BERRIMA RESIDENTS ASSOCIATION Inc

Submission by the Berrima Residents Association Hume Coal EIS June 2017

Submission by the Berrima Residents Association

Hume Coal EIS

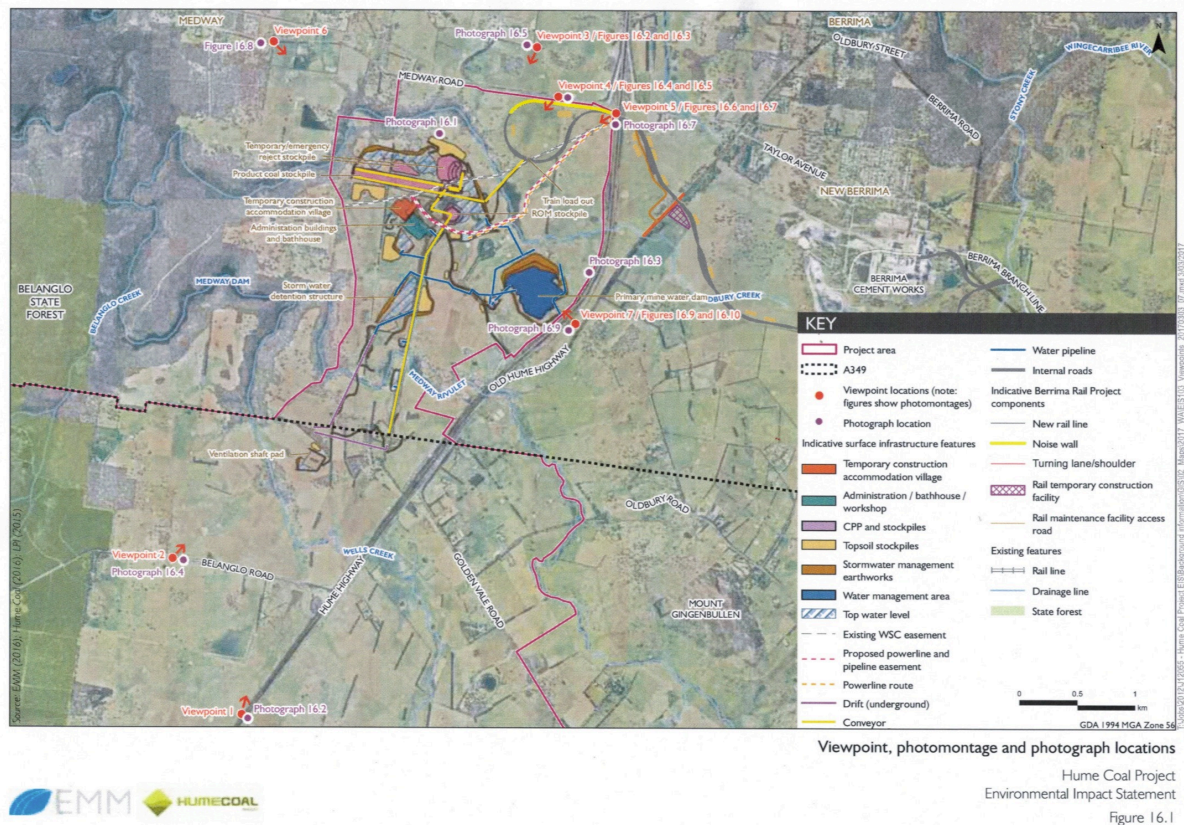
However, no assessment is presented of the noise impacts from trains traversing the proposed elevated bridge over the Old Hume Highway, which one would expect to have significant noise impact on residents living just 1250 metres away, given the height of the rail bridge above the road, and the length of the coal train.

- Hume Coal should be required to model impacts on residents from this noise source
 - It should be noted that the Berrima Residents Association has asked the Department of Planning to relocate the maintenance siding to the west side of the Hume Highway (See BRA submission of the Rail Project EIS)
 - Relocating the facility would avoid noise, light, dust and heritage impacts
- Noise from helicopters moving back and forth to the proposed heli-pad are an additional source of noise pollution; this requires a separate impact assessment.

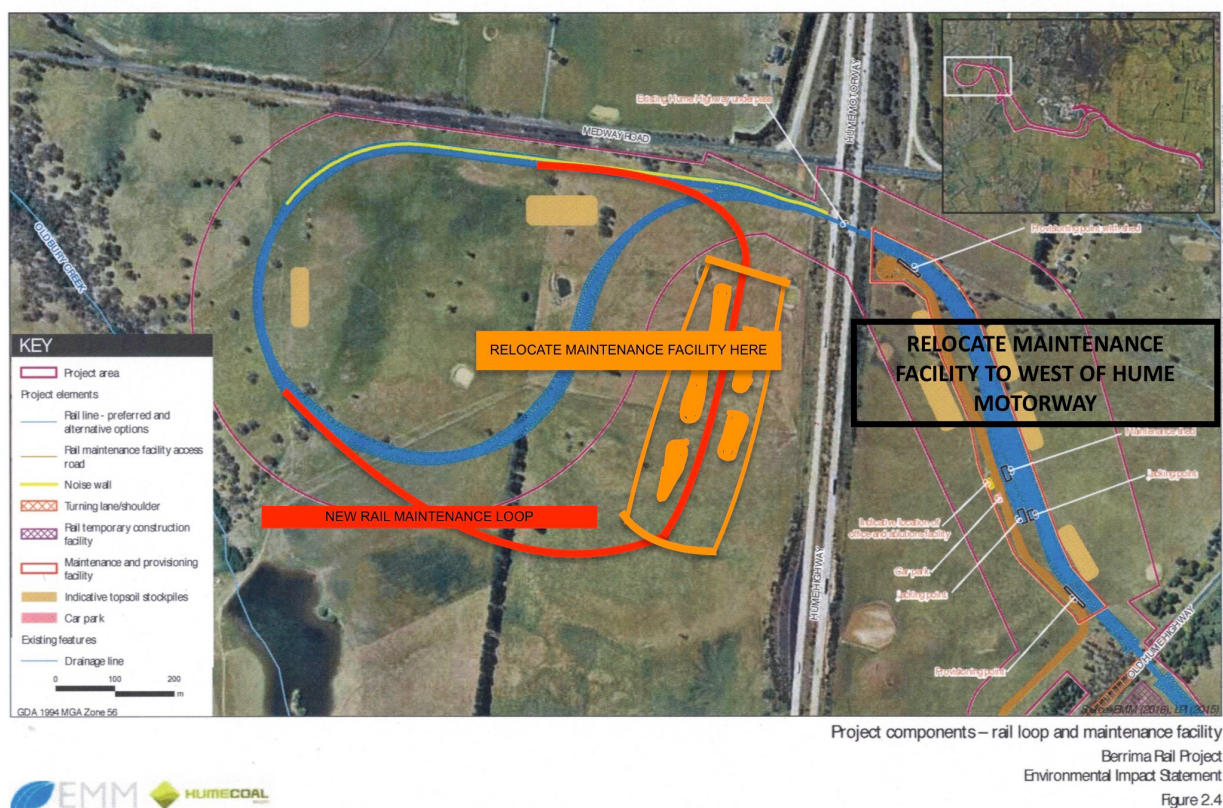
A. The adverse impacts of the proposed rail maintenance siding and related infrastructure on land between the Old Hume Highway and the Hume Highway, i.e. on the east of the Hume Highway.

The Association proposes that this facility be relocated to the west of the Hume Highway (see diagram below), and this be made a condition of approval of the Rail EIS.
